ADDENDUM NO. 1

Lincoln Road Half Street Improvements
Project No. TR6075
Grants Pass, Oregon

C2.7

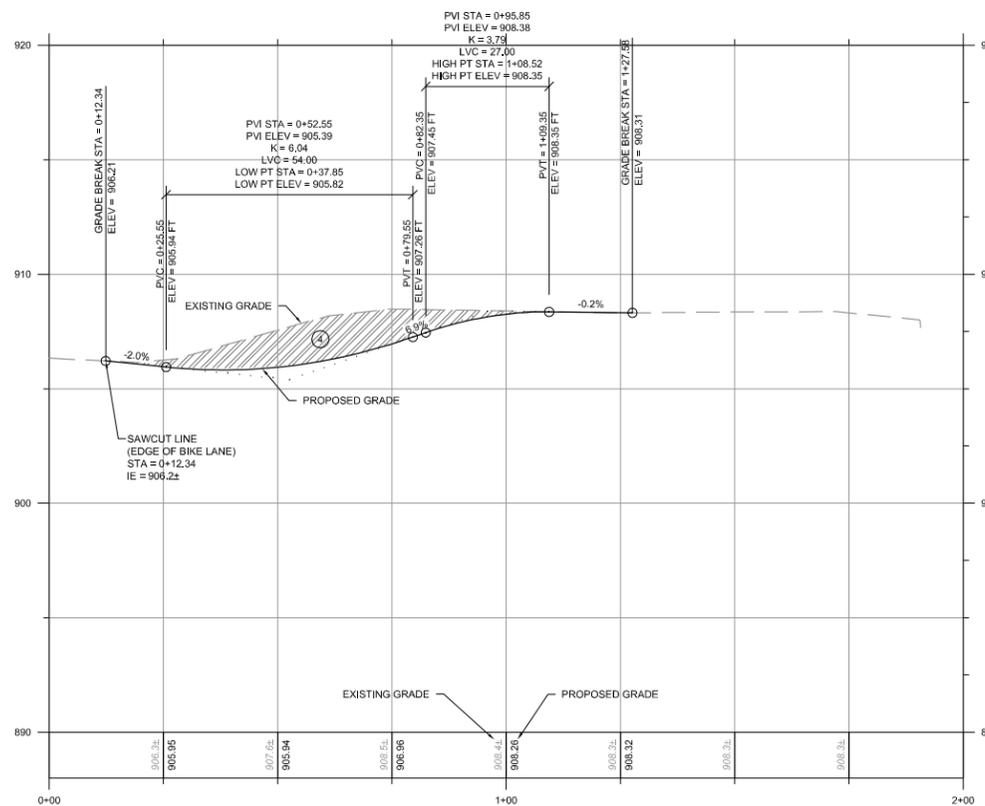
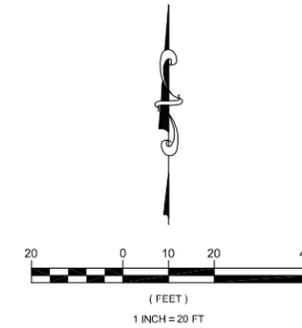
- **Sheet C2.5** - See revised plan sheet attached to this addendum showing the pipe grades for the curb inlets, pipe lengths, and curb grades.
- **Sheet C2.7** - See revised plan sheet attached to this addendum showing the pipe grades for the curb inlets and ditch inlets.
